Halawa Stream Maintenance Dredging

REVISED ENVIRONMENTAL IMPACT STATEMENT

City & County of Honolulu
Dept. of Public Works

Prepared by
VTN Pacific
1164 Bishop St., Suite 906
Honolulu, Hawaii 96813

HALAWA STREAM
 MAINTENANCE DREDGING
FIGURE 7

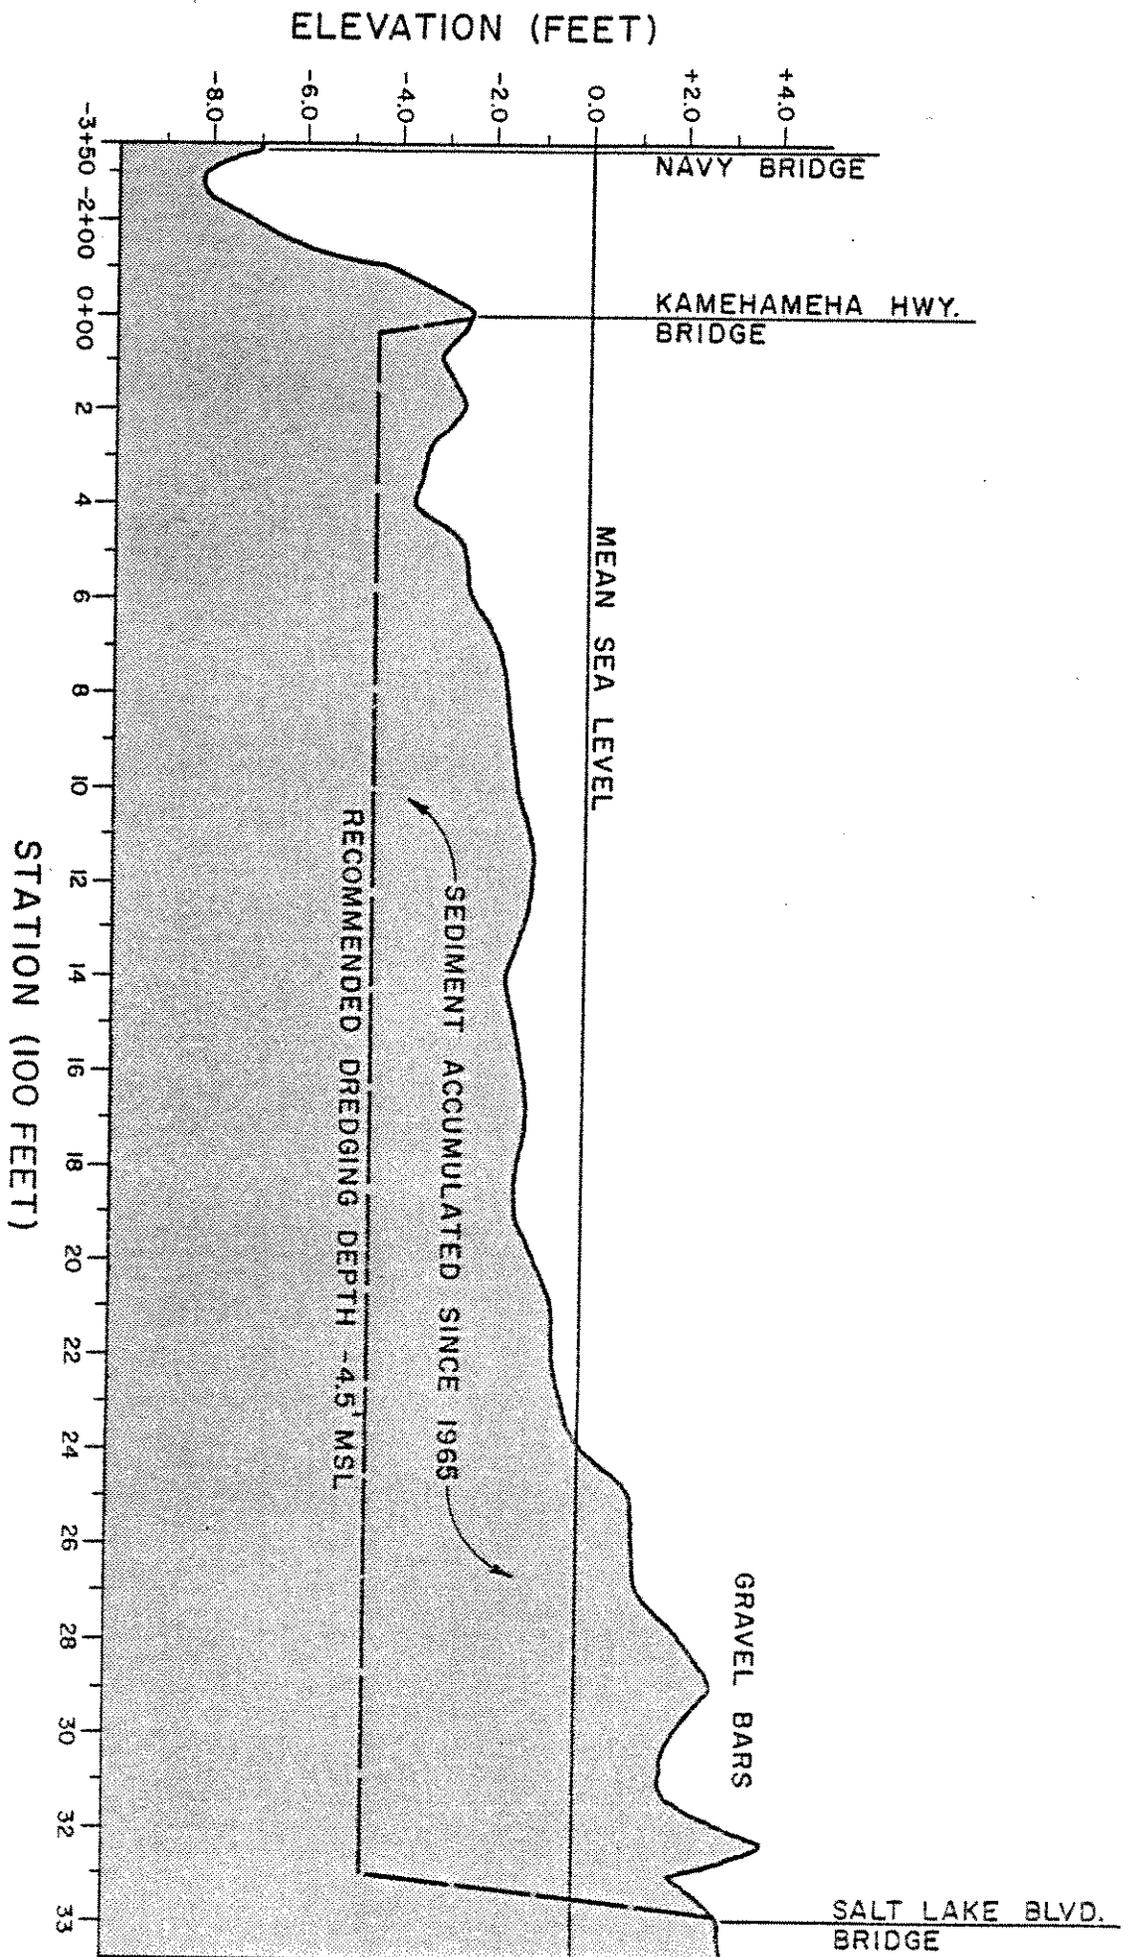
2. According to Figure 7, the bottom profile of the Lower Halawa Stream has only 900 ft. (from station 24+00 to 33+00) with maximum of 4 feet above mean-sea-level i.e. dredging of the stream bottom has no significant impact on the 100-year flood profile. On the otherhand, according to plate 13, the profiles of the backwater curves showed that the Kamehameha Highway Bridge restricts the passage of flood water to Pearl Harbor. In other words, finding ways to let the flood water pass under the Kamehameha Highway Bridge should be the key to the flooding problem. This has not been identified or elaborated in the EIS.
